# HISTORIC AND DESIGN REVIEW COMMISSION

May 18, 2022

**HDRC CASE NO:** 2022-266  
**ADDRESS:** 321 W SUMMIT AVE  
**LEGAL DESCRIPTION:** NCB 3263 BLK 6 LOT 10  
**ZONING:** R-5, H  
**CITY COUNCIL DIST.:** 7  
**HIST. DIST. NAME:** Monte Vista  
**APPLICANT:** Ashley Ricketson/Locksley Architecture + Design Studio  
**OWNER:** DAVID PHIPPS/321 W SUMMIT AVE  
**TYPE OF WORK:** Porch modifications, windows, repair and maintenance  
**APPLICATION RECEIVED:** April 28, 2022  
**60-DAY REVIEW:** Not applicable due to City Council Emergency Orders  
**CASE MANAGER:** Jessica Anderson

1 FLOOR PLAN  
1/2" = 1'-0"

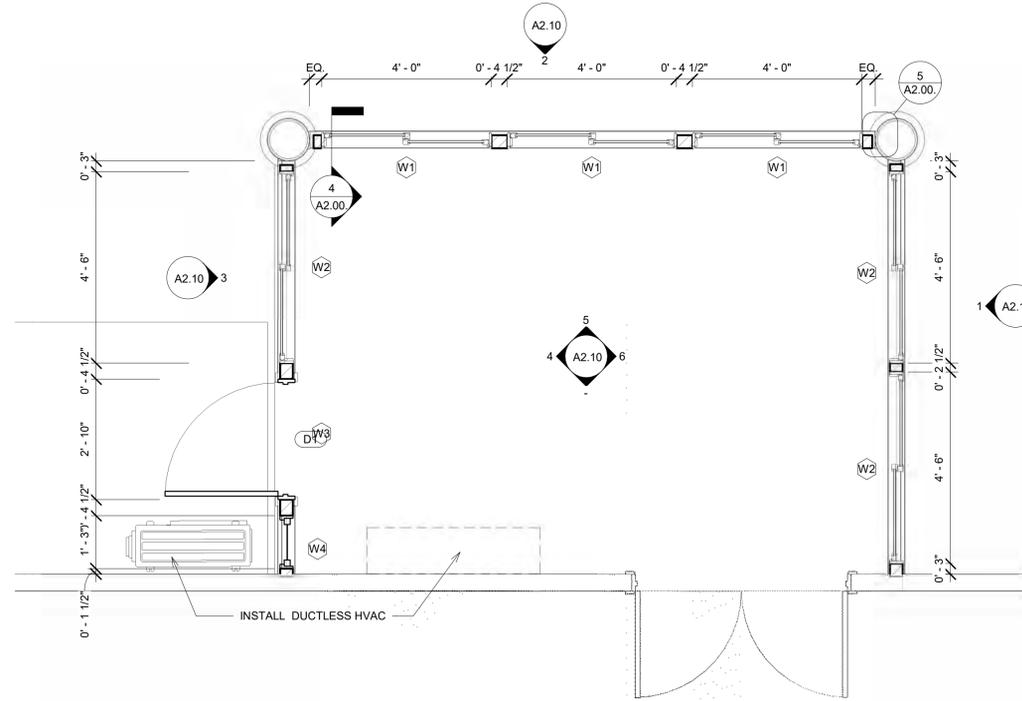
- d. **PORCH MODIFICATION:** The applicant has proposed to enclose an existing side porch with windows; the porch is currently enclosed with screen. According the historic design guidelines for exterior alterations and maintenance 7.B.ii., alterations to side and rear porches should result in a space that functions, and is visually interpreted as, a porch. Staff finds that the proposed enclosure does not obstruct any original architectural features and allows the porch to still function and be visually interpreted as a porch.

- e. **WINDOWS:** The applicant proposes replacing screens with Wincore 8400 Series white vinyl windows. Staff finds the proposed replacement windows do not conform to staff’s standards for replacement windows.

Staff recommends approval of item 2, replacement of screens with vinyl windows, with the following stipulation:

- i. That the proposed windows be wood or aluminum-clad wood.

2 EXTERIOR ELEVATION - SIDE  
1/2" = 1'-0"

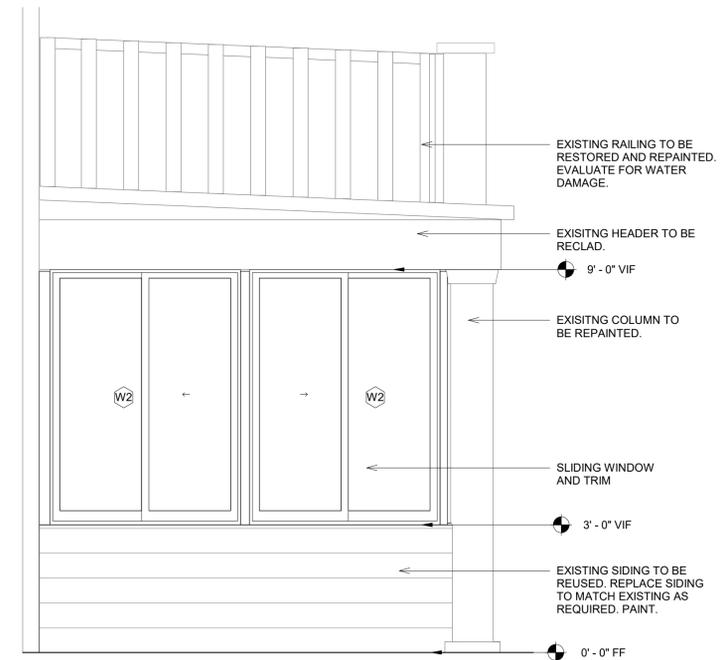
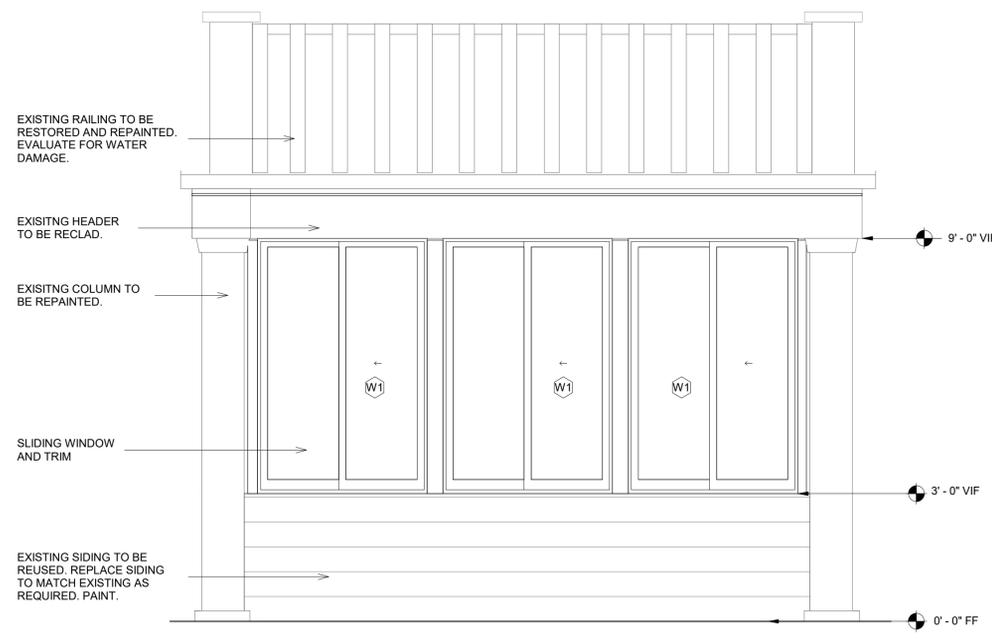
- f. **DOOR:** The applicant proposes replacing a screed door with a 15-lite door. According the historic design guidelines for exterior alterations and maintenance 6.B.i and v, new doors should match the material and profile of the historic element, and use an exterior muntin pattern, profile, and size appropriate for the historic building when replacement windows are necessary. Internal muntins sandwiched between layers of glass should not be used.

- i. That the door be wood and not feature a faux divided lite configuration.
